UNITED STATES PATENT AND TRADEMARK OFFICE

APPLICATION NO.	FILING DATE	FIRST NAMED INVENTOR	ATTORNEY DOCKET NO.	CONFIRMATION NO.
10/722,606	11/28/2003	Chin-Chih Lin	BHT - 3092 - 395	8251

Office Action Summary	Application No. 10/722,606	Applicant(s) LIN, CHIN-CHIH	
	Examiner Tan Le	Art Unit 3632

DETAILED ACTION

FIG. 2

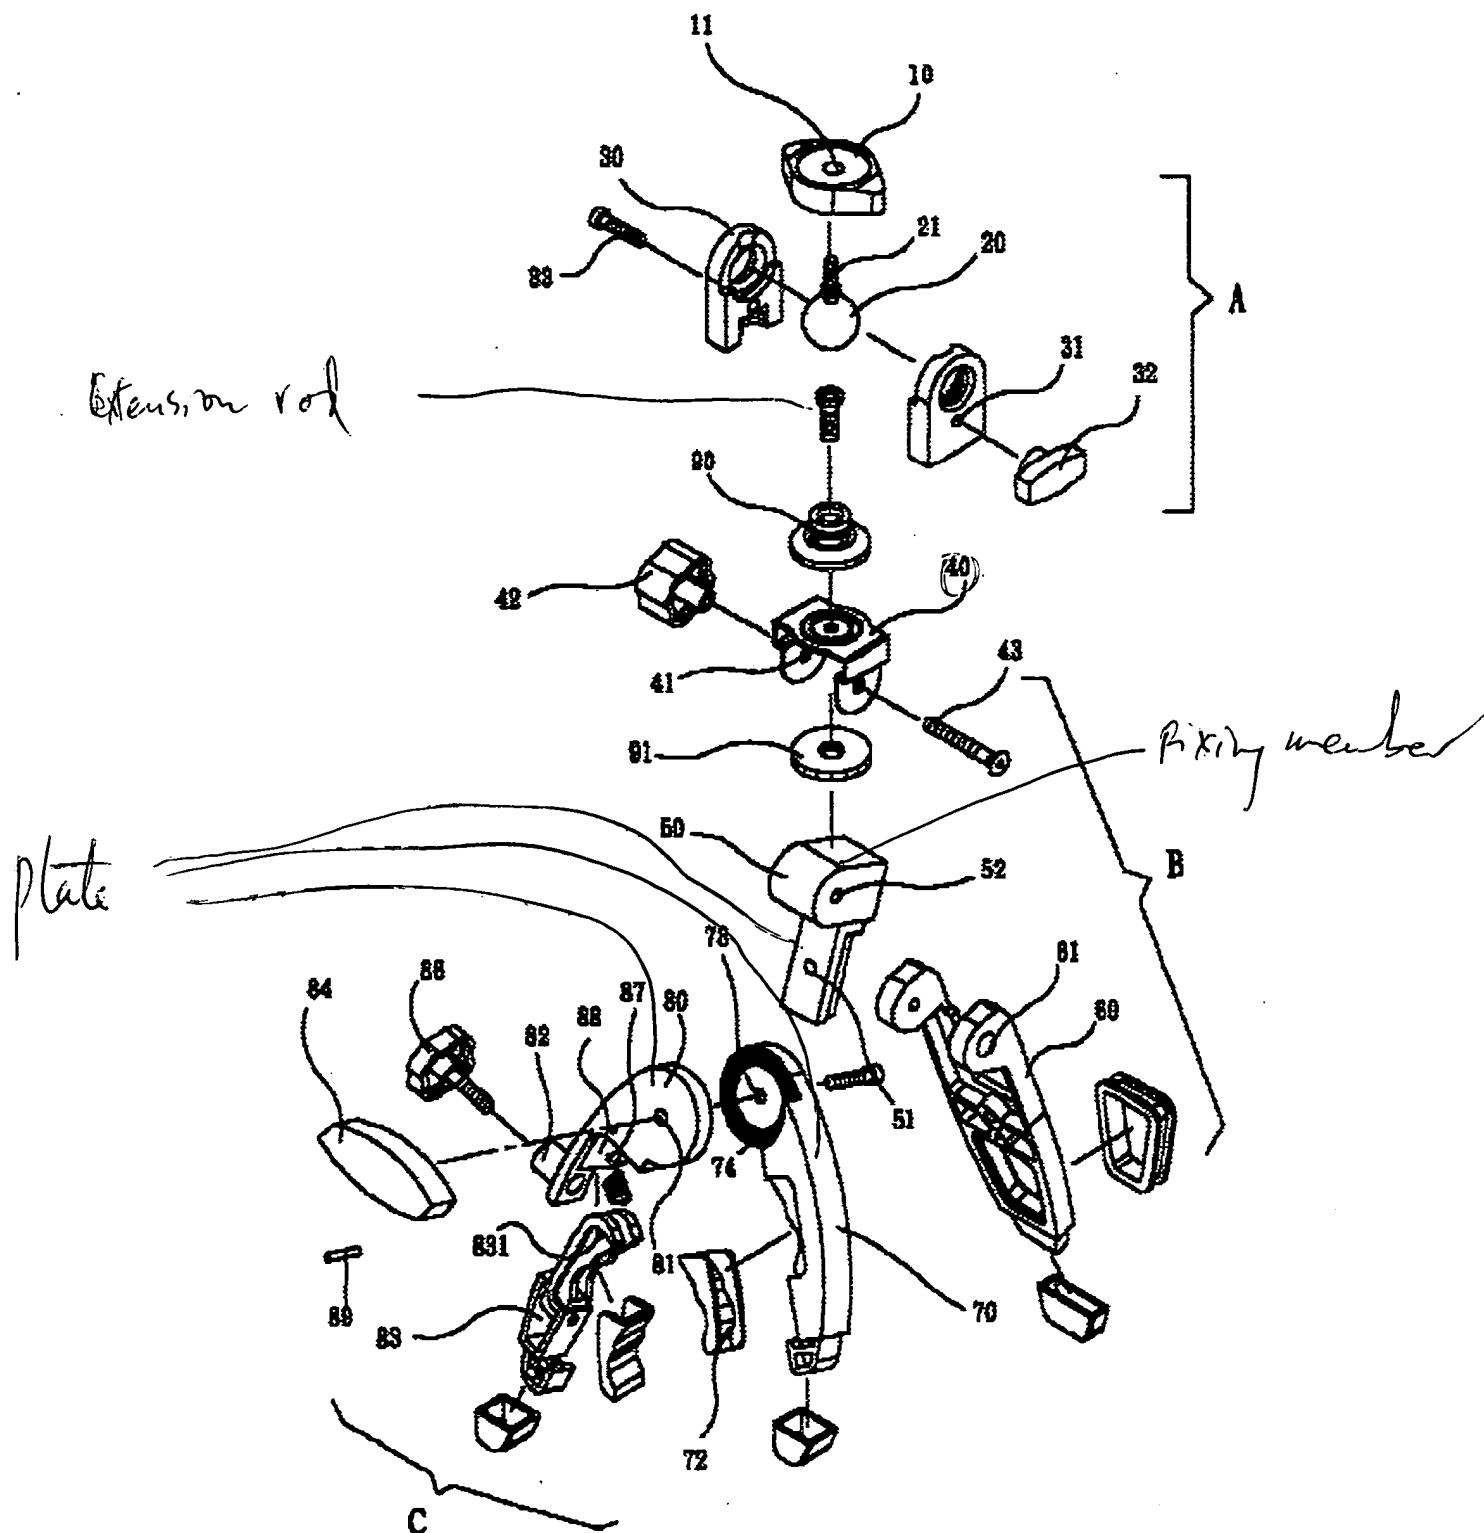
Claims 1, 4-5 and 13 are rejected under 35 U.S.C. 102(b) as being anticipated by US Patent No. 6,579,017 to Wei.

Regarding claim 1, Wei teaches a tripod, which enables the user to conveniently adjust the position of the camera platform horizontally as well as vertically, comprising: a bottom plate (70, 80) (Fig. 2) (see marked-up copy), a fixing member being mounted at a front side of the bottom plate and being composed of a support base and a joint seat (50) with the joint seat at a center thereof having a through shaft groove (52), a rotational member (40) being a U shaped frame, extending downward along two lateral sides thereof a wing plate (where hole 41 located) respectively with the wing plate beside an inner side thereof being a packing ring (91) and a space in between fitting with the joining seat and an axial bolt (43) passing over a securing hole (41) of the two wing plates and the shaft groove (52) with an end of the axial bolt (43) being engaged to one of the wing plates and another end of the axial bolt (43) being engaged to a threaded fastener (42) to commonly enclose and press against two lateral sides of the joining seat (50); and a spherical nest device having a positioning ball (20) with an extension rod (a threaded fastener)(no numeral) being enclosed with a semi-spherical durable ring (30) at two lateral sides thereof respectively, being covered with a blocking

lid (90) and a front cover (10) in a way of the extension rod piercing outward through the blocking lid to engage with the rotational member (40) such that the rotational member can be adjusted an inclining angle backward and forward with respect to the fixing member and the front cover (10) can be multi-directionally adjusted with respect to the positioning ball.

Regarding claim 4, Wei also teaches the bottom plate being provided with plate holes (73, 81) or plate grooves for being passed through with screws such that the bottom plate can be attached to a stationary object.

Regarding claim 5, Wei teaches the bottom plate at a center thereof is provided with at least a piercing hole (73, 81) and the fixing member at a support base thereof has a corresponding threaded hole (51) disposed at a bottom edge thereof such that threaded hole (51) can engage with a screw (no numeral) passing through the piercing hole so as to join the bottom plate and the fixing member.

Regarding claim 13, Wei also teaches the fastener being a hand knob threaded bolt (42, 43).
